# DESIGN INTEGRITY REPORT

# POWERHOUSE PARRAMATTA

18 SEPTEMBER 2020

Setbacks Diagram

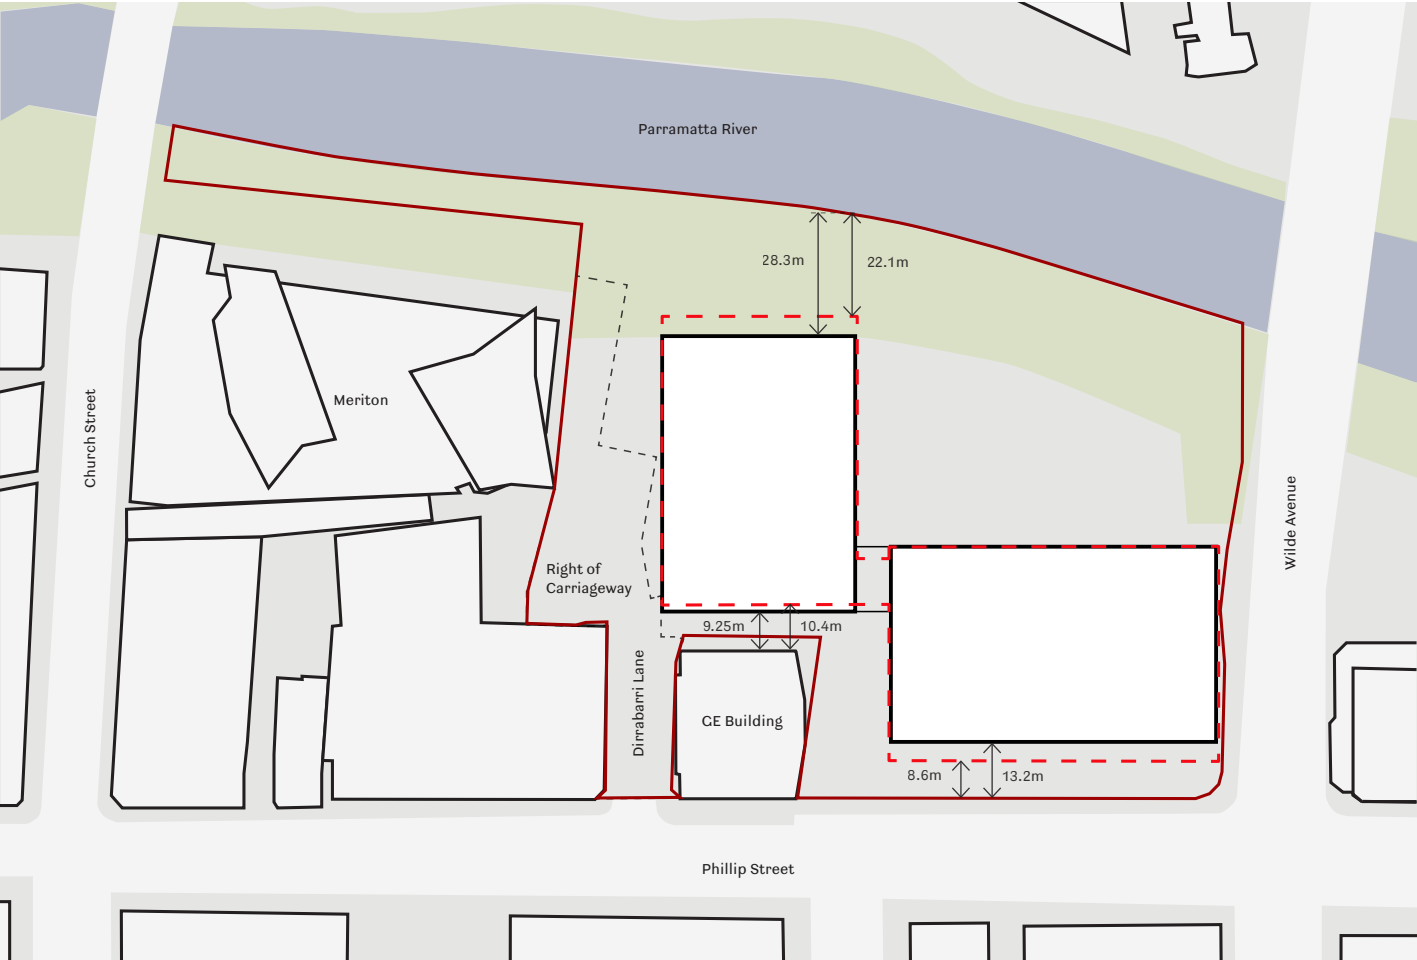
The overall building height and footprint has been reduced in the amended design that forms the basis for the Response to Submissions. The Panel acknowledge the design development process has resulted in further development of the concept, creating efficiencies and aligning the design to feedback received in submissions and the project budget.

As outlined in the figures below, tthe built form has reduced in footprint and height. This reduction has led to a number of layout changes internally within the building as detailed in the Architectural Design Report Addendum within the Response to Submissions.

The Panel consider the reduction in footprint and height of the building acceptable as it maintains the overall proportions of the design. Key elements such as the exo-skeleton and façade composition have been retained not inhibited by the reductions and enhanced as detailed in section 4.4. The Panel caution that any further reduction to the scale and proportion of the building has the potential to diminish the presence of the concept design/ proposal.
